TO	Kevin Kim
OF	LIVERPOOL CITY COUNCIL
FROM	Bureau SRH
CONTENTS	28 Yarrunga St – PPSSWc-87 - DA-904/2019

PROJECT NO	18144
DATE	31/07/20
DELIVERY	PDF
PAGES	8

I refer to Sydney Western City Planning Panel's (SWCPP) recent Record of Briefing for a briefing held on 13.07.20. over development application for 28 Yarrunga St, Prestons – DA-904/2019. Below is our response to the points raised in SWCPP's Record of Briefing issued electronically to the Client and yourself on 16th July 2020.

Figure 1 – 28 Yarrunga St façade and sectional street front analysis.

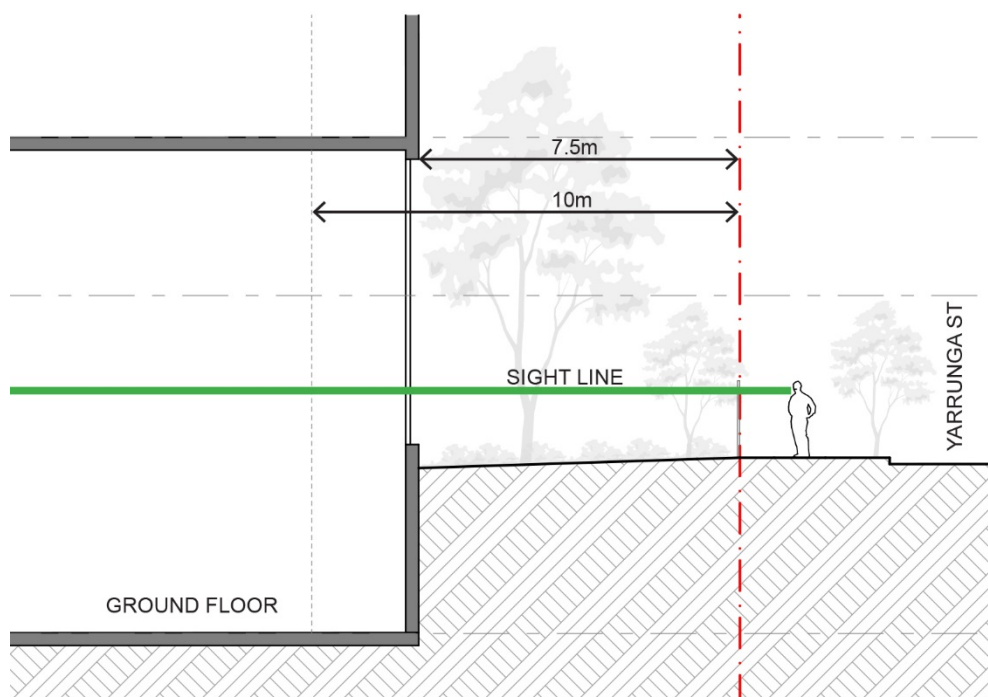
- The reduced front setback for the ground floor level of the proposed stage 1 building, as well as variation to the minimum landscaped area and deep soil area of 10%. The Panel indicated that these departures would need adequate design justification in relation to impacts on the surrounding streetscape. The Panel noted that the site generally in unencumbered, such that achieving the standard would not normally seem overly onerous.***

Figure 1 above demonstrates a premium presentation to Yarrunga St through transparent façade detailing that offers a greater depth of field than would otherwise be provided by the 10m requirement. Not only does the alternating glazed to solid façade ratio create a visually distinctive street presence, it also contributes to a heightened sense of internal amenity with direct connectivity to the street.
